Delegated Report		Expiry Date:		02/10/2024	
		Consultation Expiry Date:		05/09/2024	
Officer		Application Number(s)			
Leela Muthoora		2024/3073/P			
Application Address		Drawing Numbers			
153 Fortess Road, London, NW5 2HR		See draft decision notice			
Proposal					
Installation of a ventilation extract duct from ground floor restaurant to rear roof level.					
Recommendation:		Refusal of planning permission			
Application Type:		Full Planning Permission			
Consultations					
Summary of consultation:		Two site notices were displayed near to the site on the 09/08/2024 (consultation end date 05/09/2023).			
Summary of consultation responses:		No. of responses	02	No. of objections	02
		<p>Three letters of objection were submitted from, or on behalf of the owners/occupiers of the flats within the upper floors of the site. Their objection comment can be summarised as follows:</p> <ul style="list-style-type: none"> Noise and vibration nuisance from the ventilation/ extraction system. Noise assessment measurements not taken at first and second floor flats. Proximity to residential windows serving bedroom and exiting through first floor terrace. Duct itself will block light to windows Uns

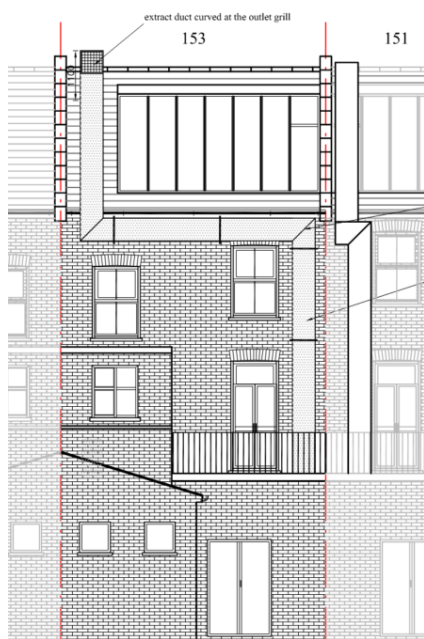
3.4. The proposal would be sited close to an existing ventilation duct at 151 Fortress Road. This was granted conditional planning permission in 1997 and pre-dates existing planning policy and guidance. The proposed duct and cumulative effect of scale and bulk of the two ducts together would appear unduly prominent, detracting from the character and appearance of the host property. Furthermore, while there are existing flues in the area, these tend to be sited so they are less dominant and in any event would not justify further harm caused by the proposal.

3.5. As a result, the proposed extract duct, by means of excessive height, bulk, design and materials, would dominate the rear elevation of the host building and appear as incongruous visual clutter detracting from the character and appearance of the host property, terrace, and the surrounding area, contrary to policy D1 of Camden Local Plan 2017 and CPG Design.
